Re:- Building Dharamsalla & Bhojanshalla & Chawl
on plot No. 520, E-4 Runchore Quarter, Acc. No. 6.
See How Submitted.

NOTICE UNDER SECTION 96 OF ACT III OF 1901.

Sharunshalla & BhopanshallaAnd Chowkon plot No. 520Survey Sheet No. 8.4

PLAN OF PROPOSED DHARAMSALA CHOWL AND DINING SHED ON PLOT NO 520 E.4 RUNCHORE QUARTER SCALE 8"=1"

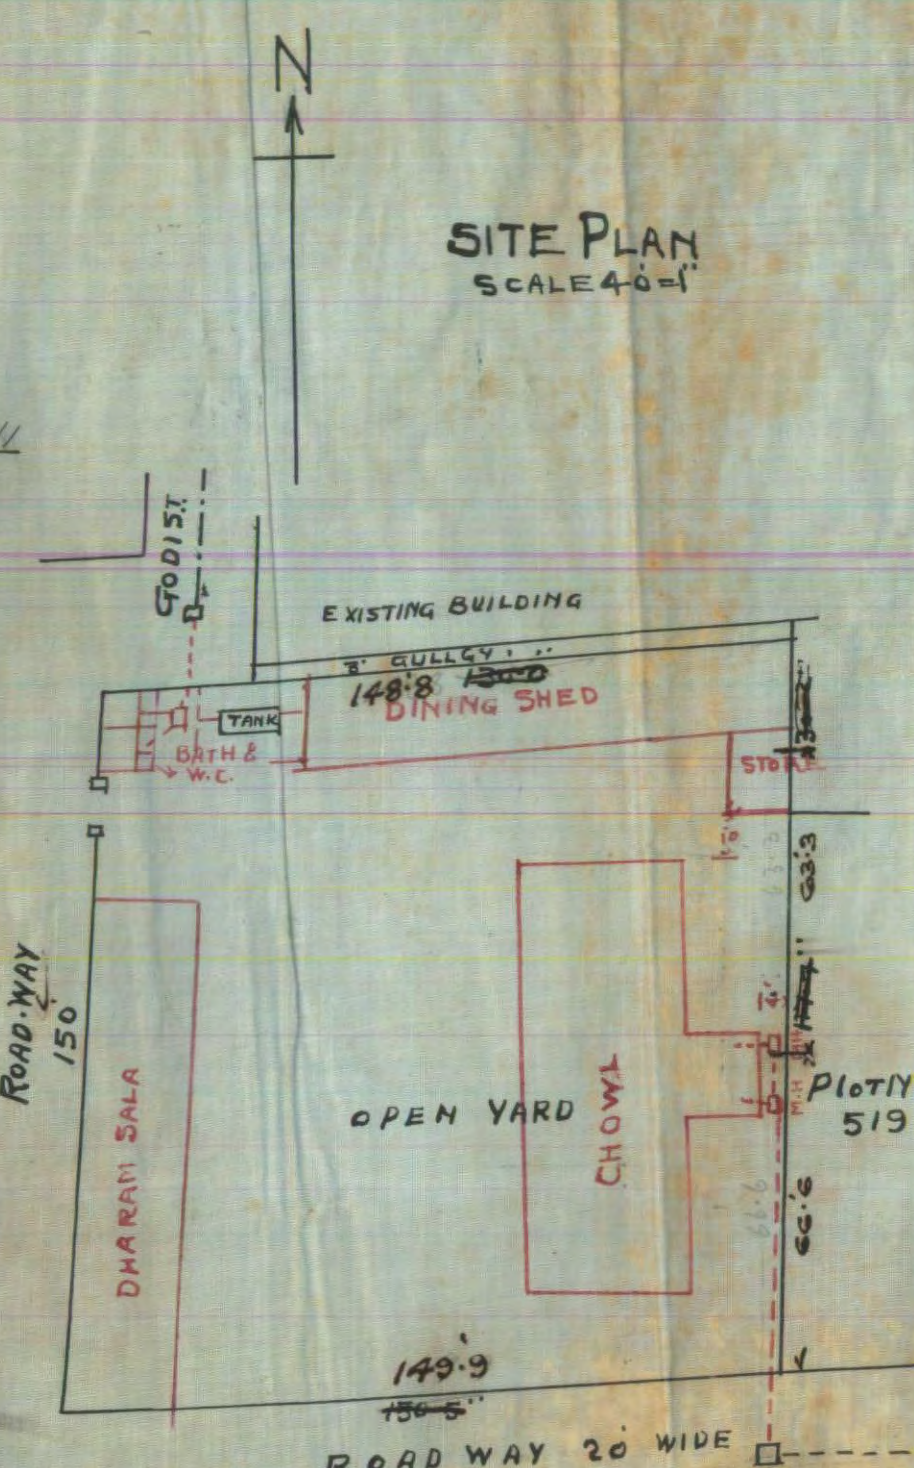
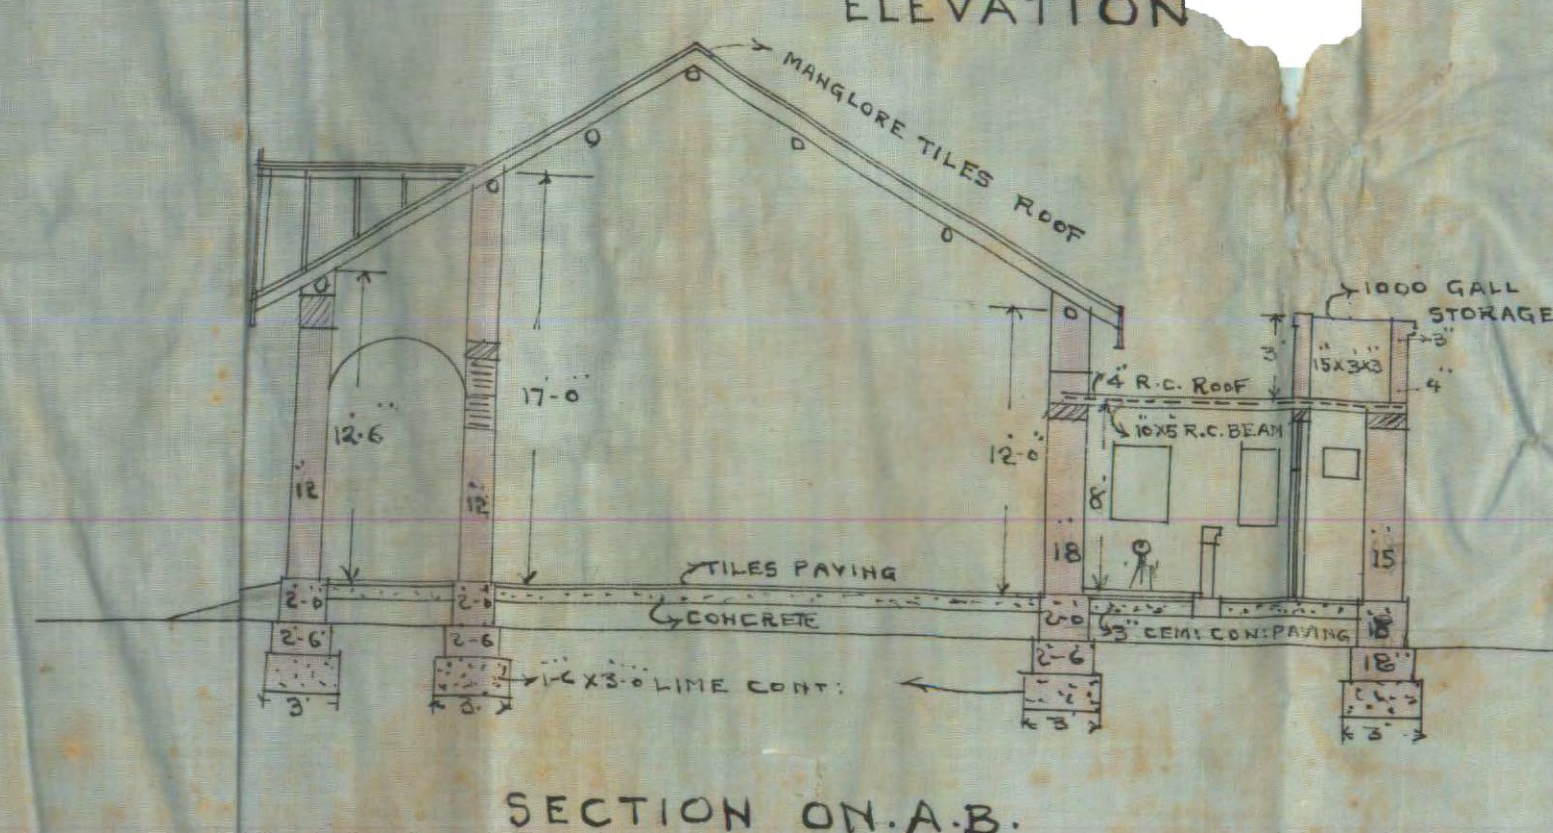
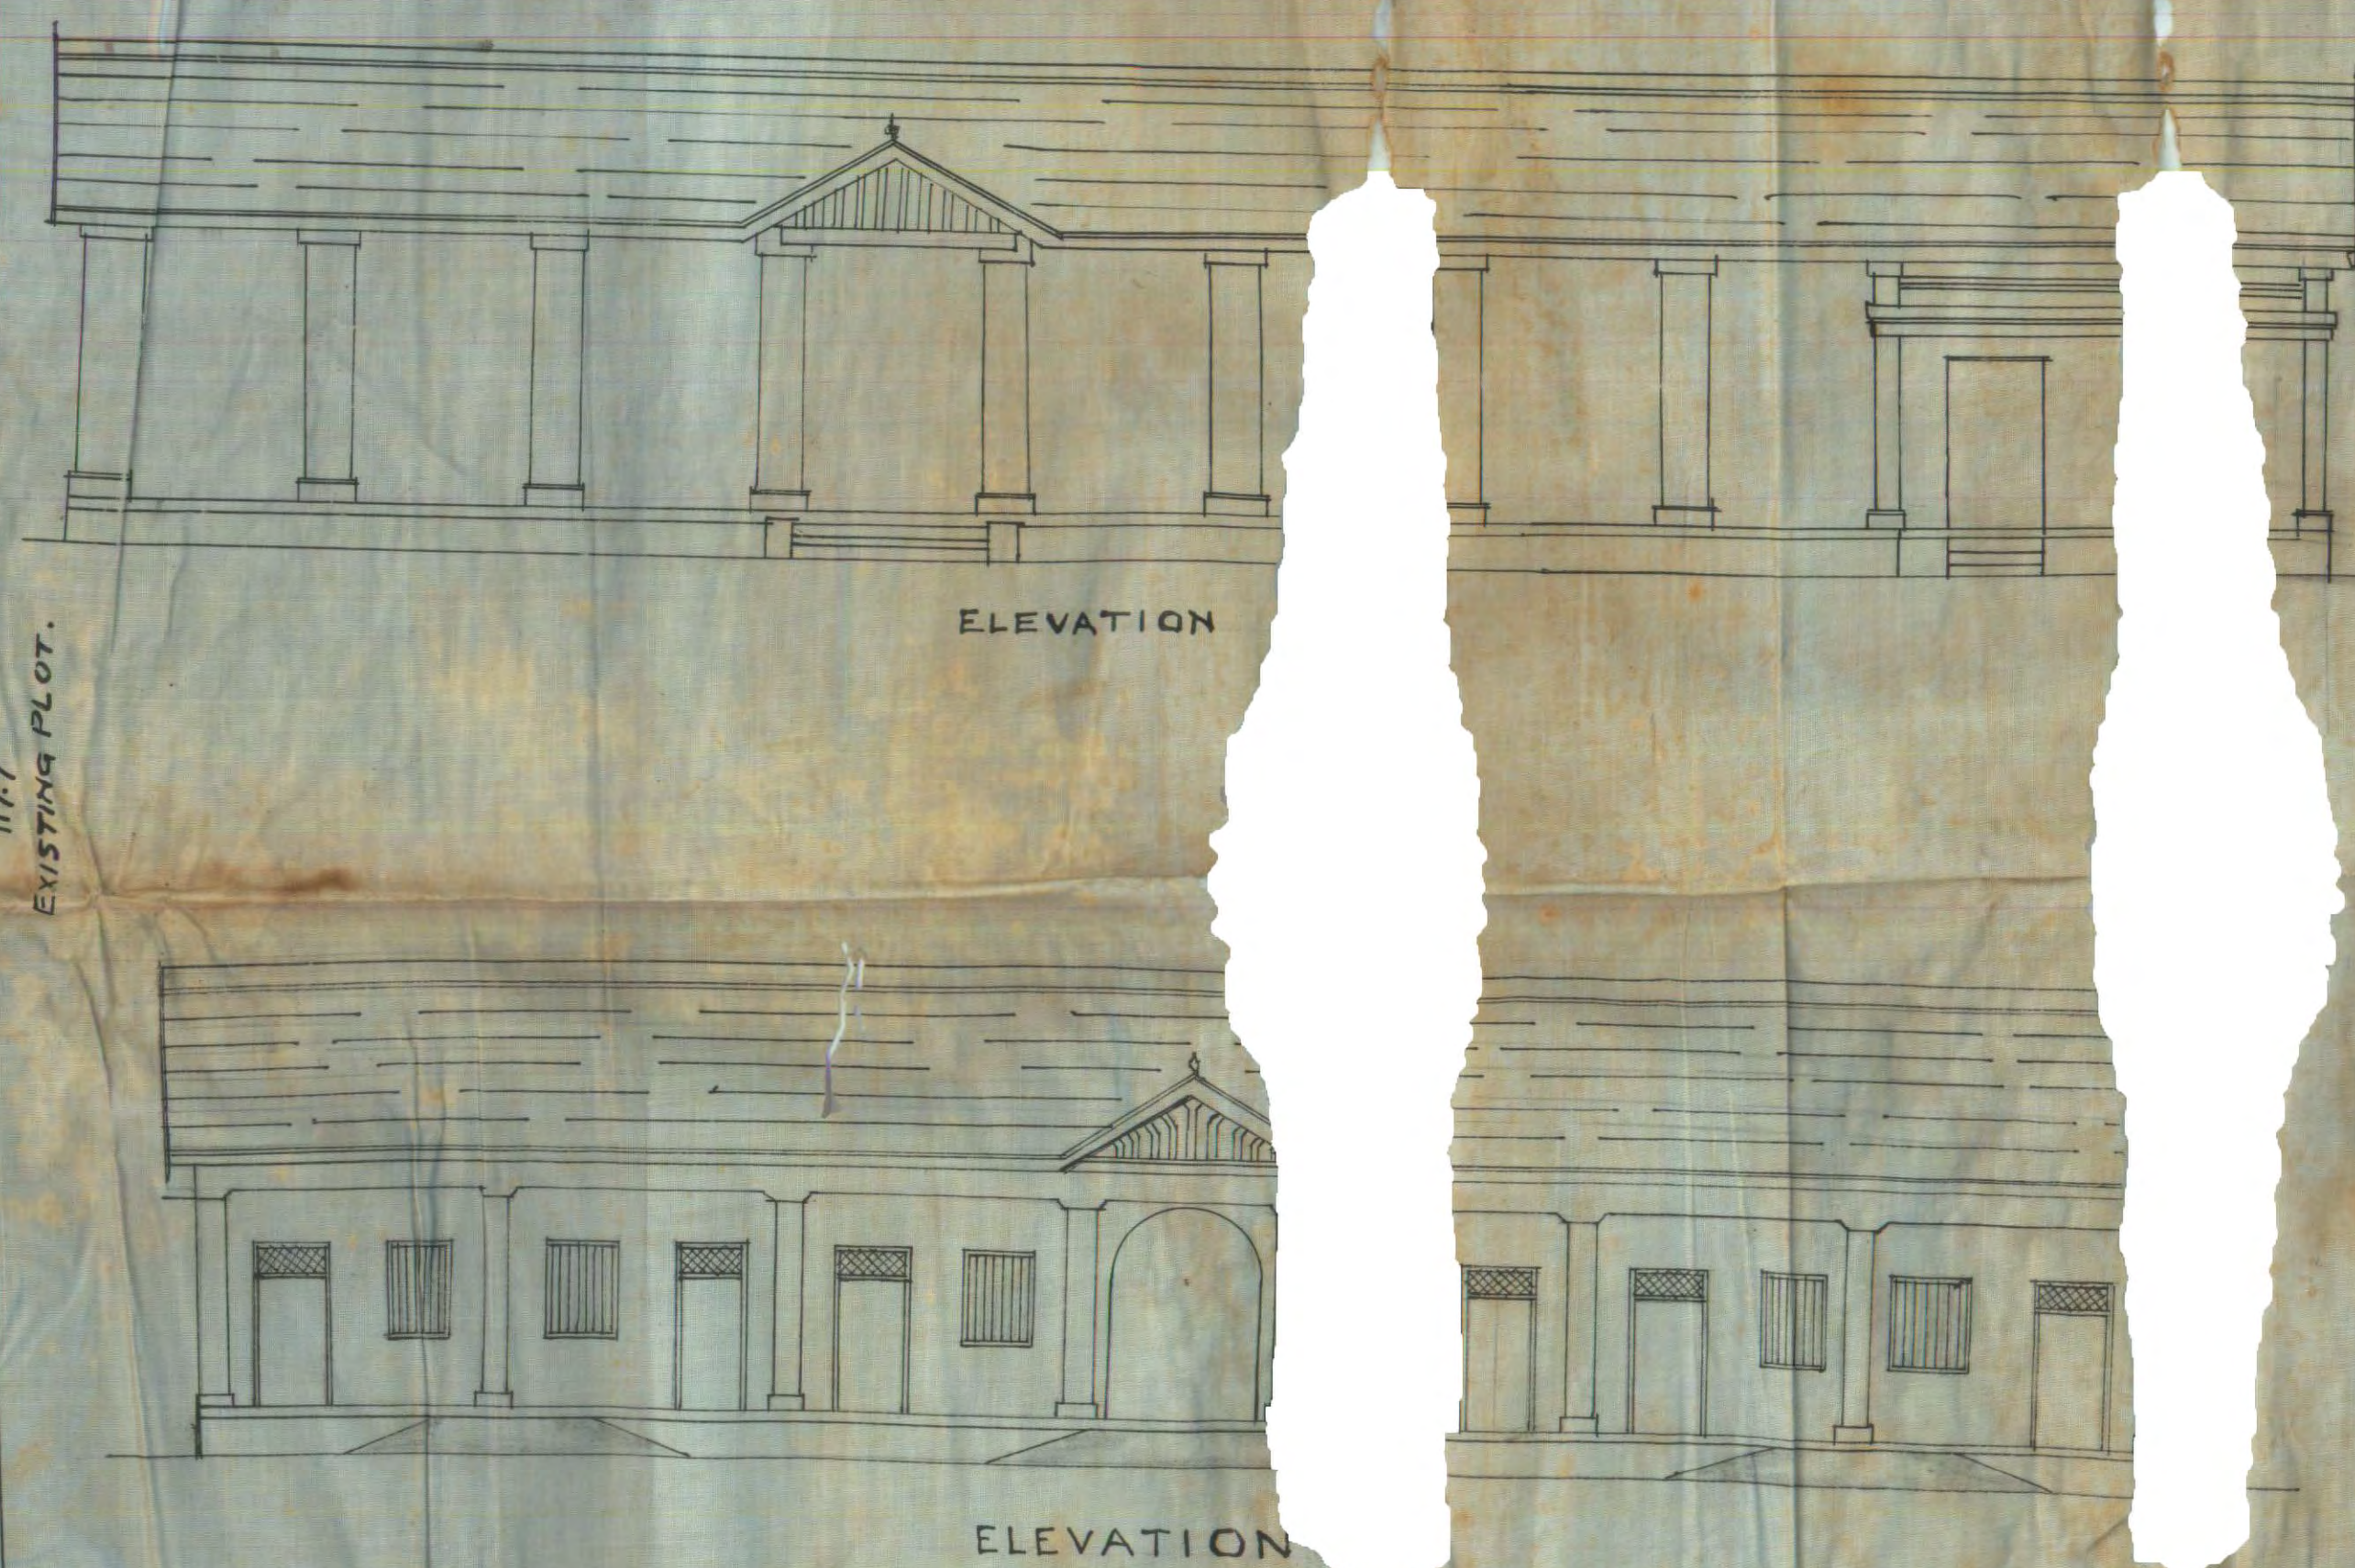
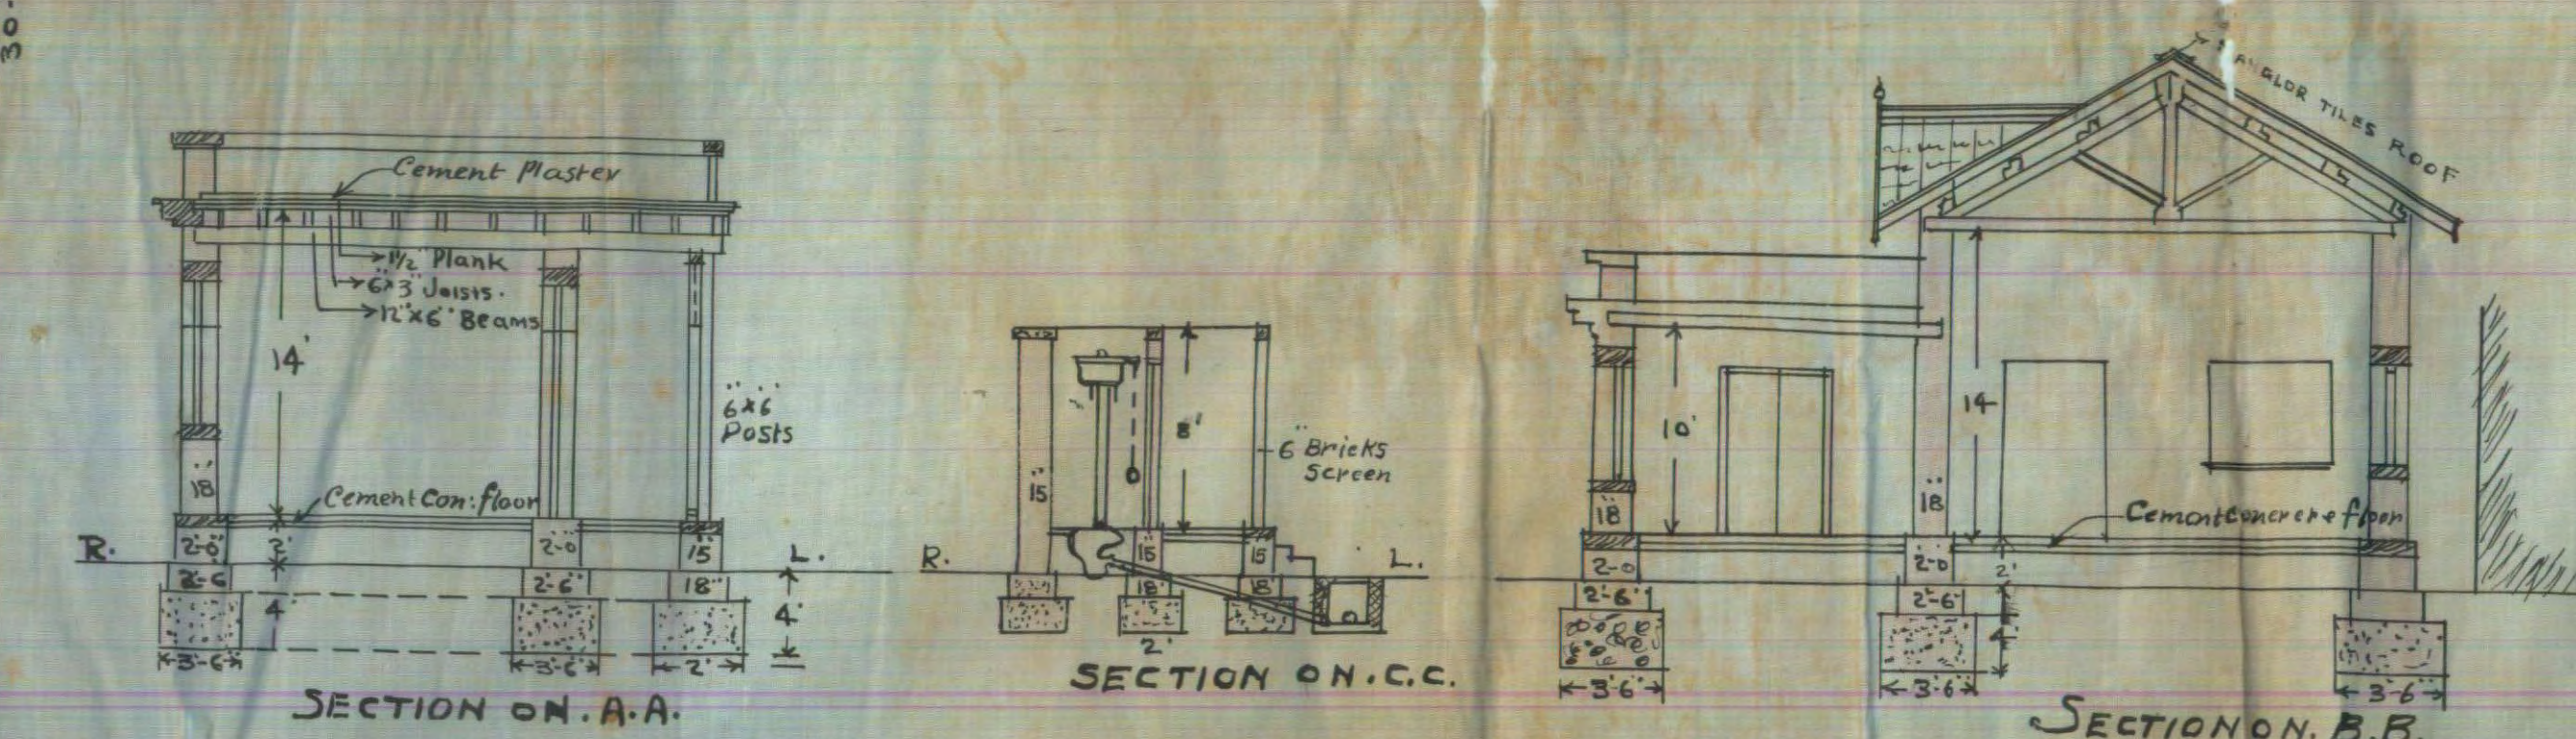
1. Thickness of wall should be 15" instead of 12 inch.

2. Size of window opening should be wider.

3. Tiles also should be submitted.

Remarks Submitted. It is proposed to provide

a road through this plot as per map of the

no. 6. m. a. 5048 of 4/1/25.

Since the side dimensions are not aligned

corrections have been made in the accompanying.

Please prepare the proposed road in Section + ground plan
